The Sizewell C Project

9.115 Response by SZC Co. to RSPB's Comments at Deadline 8

September 2021

Figure 5:

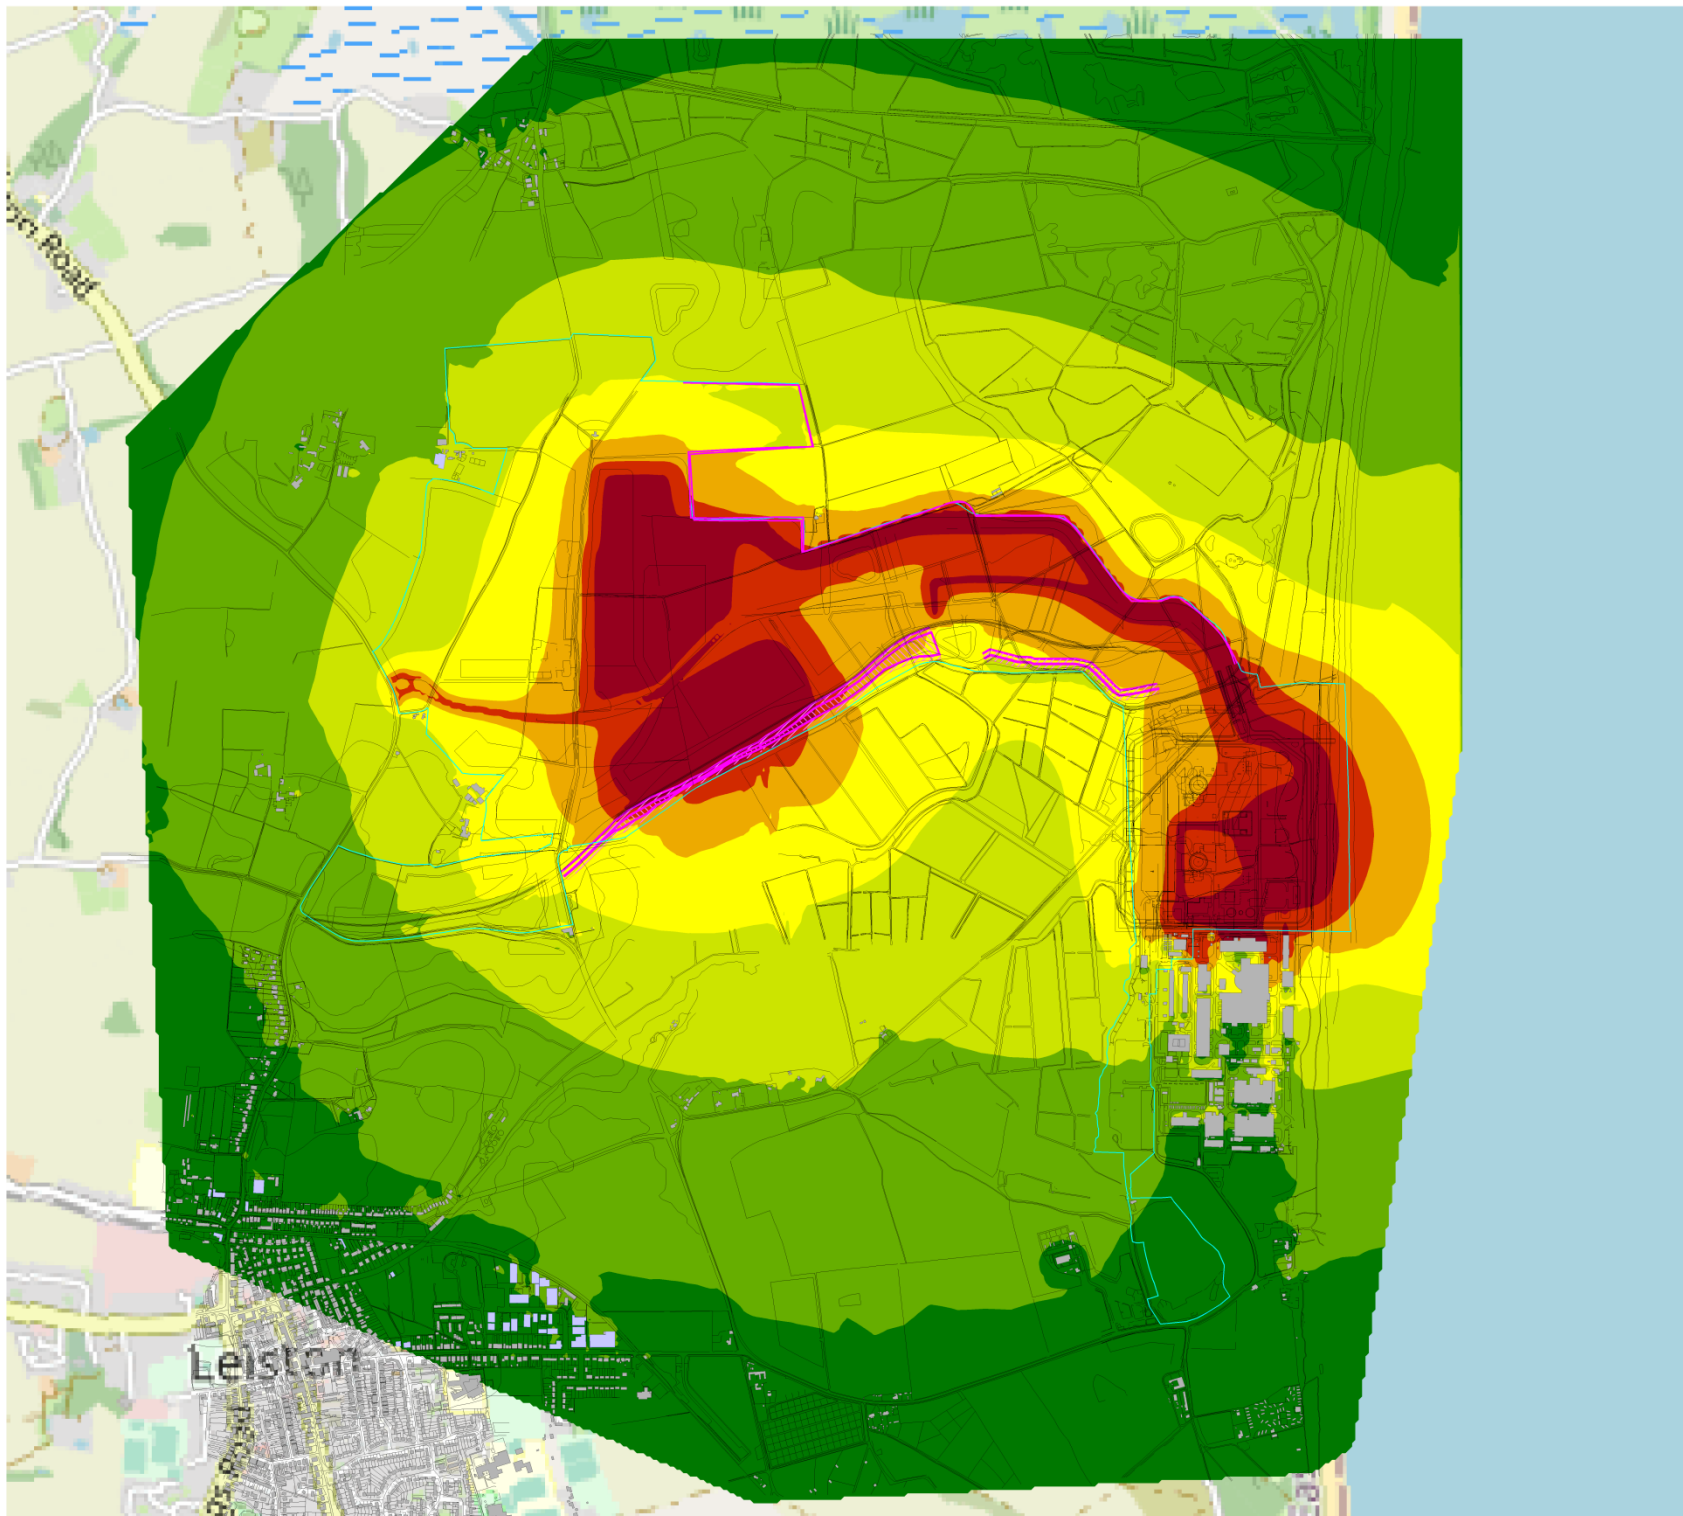
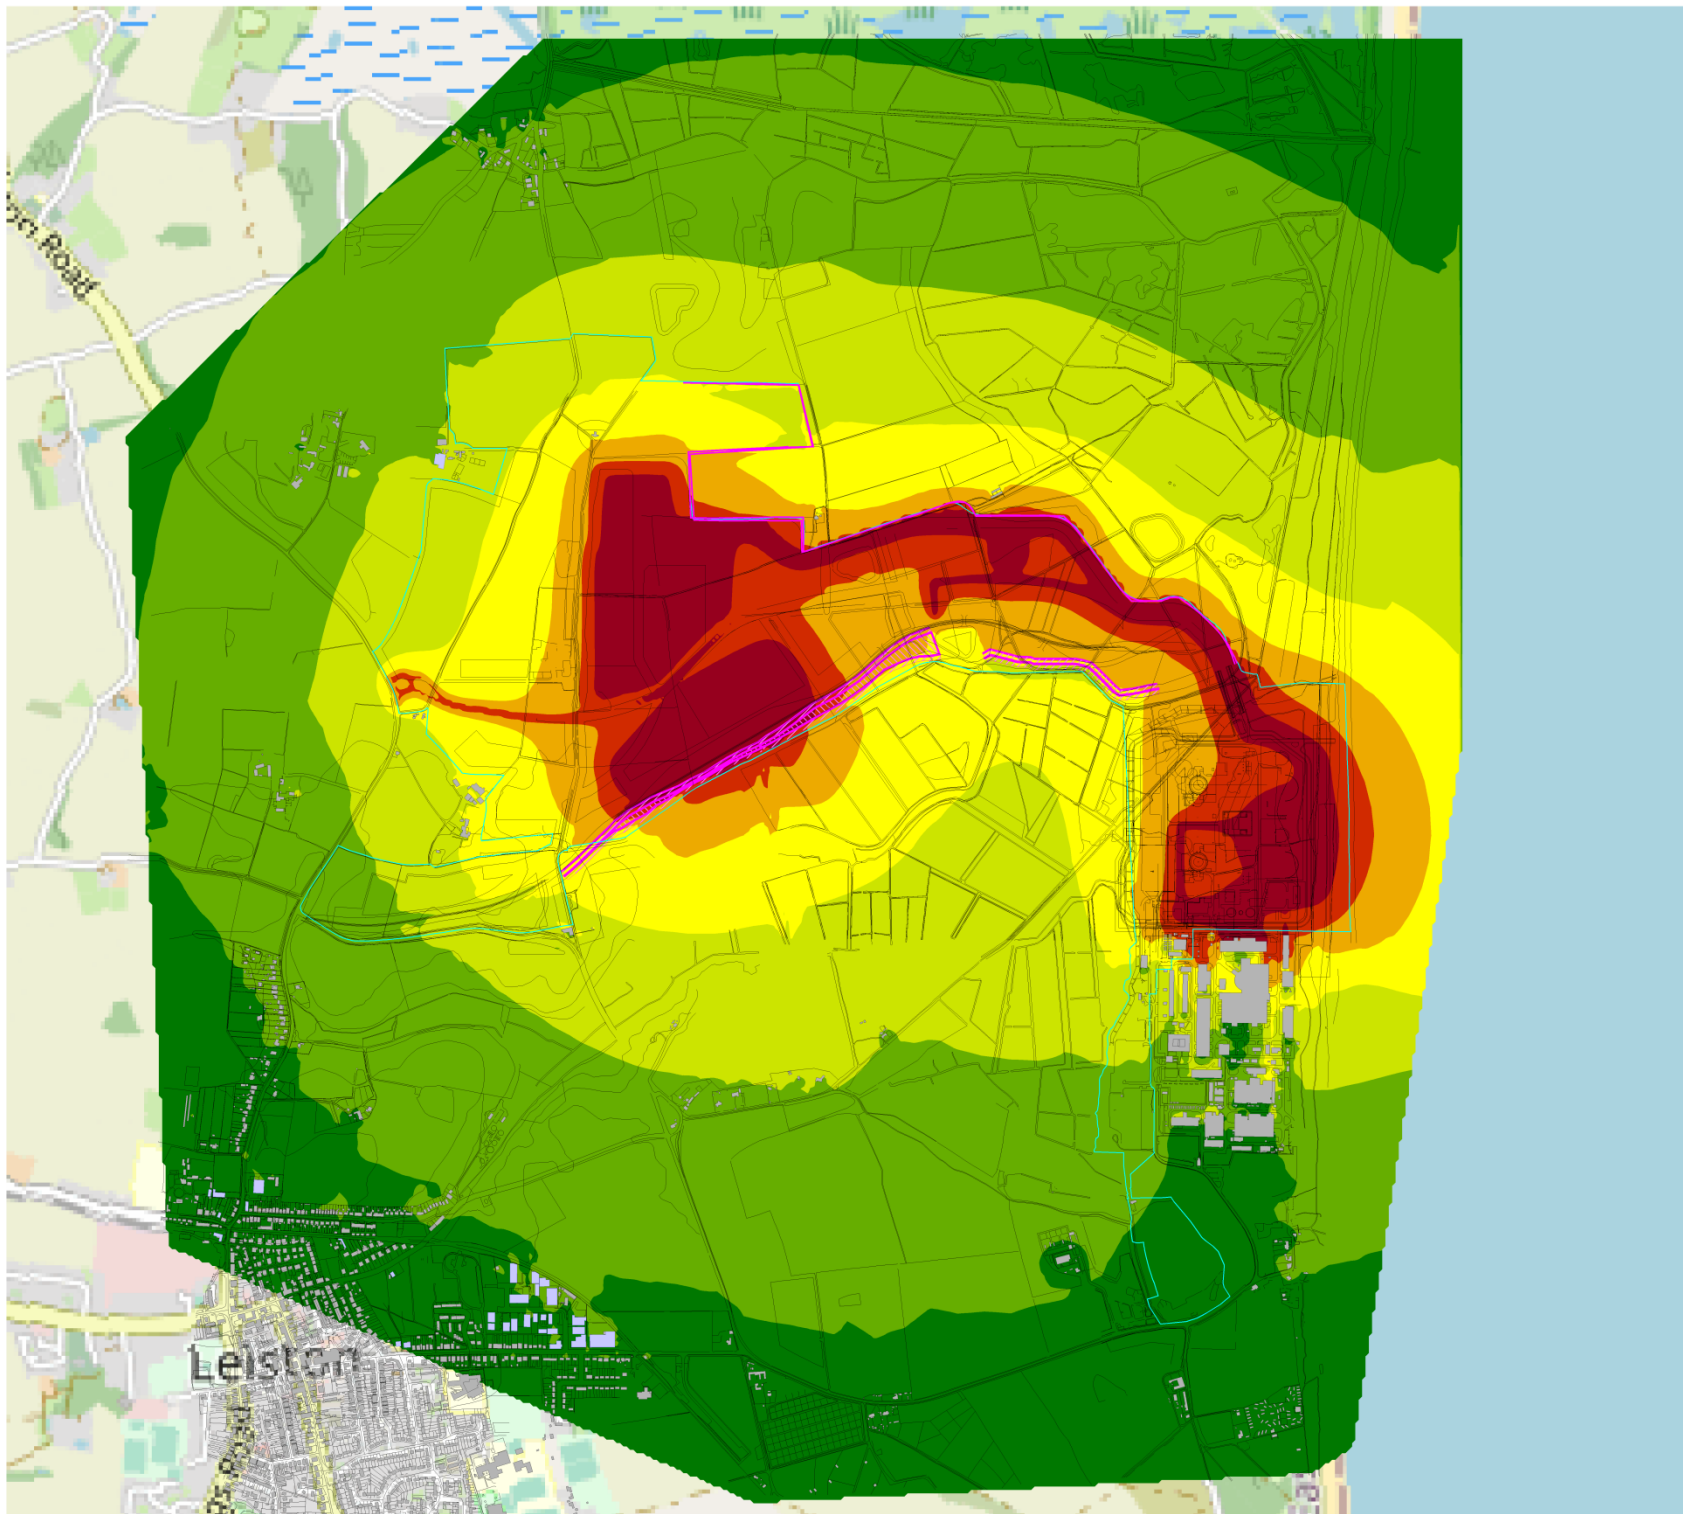
of operation of the desalination plant. We understand that the additive effects of different noise sources are limited when those sources emit similar noise levels but query the additional effects of the Change 19 during those construction phases where other construction noise is lower.”

- 1.3.22 The same comparison has been made for the night-time period, when other activities are expected to be reduced and therefore quieter. This night-time period represents the scenario with the lowest noise levels from other works, and therefore the greatest potential for an increase in noise level as a result of the desalination plant.

- 1.3.23 Figures 5 and 6 show the night-time Phase 3/4 noise levels without and with the desalination plant respectively.
- 1.3.24 It can be seen from Figures 5 and 6 that there is no material difference between the noise levels, outside of the location of the desalination plant itself. There is a small increase in noise at the location of the desalination plant, but not beyond it.
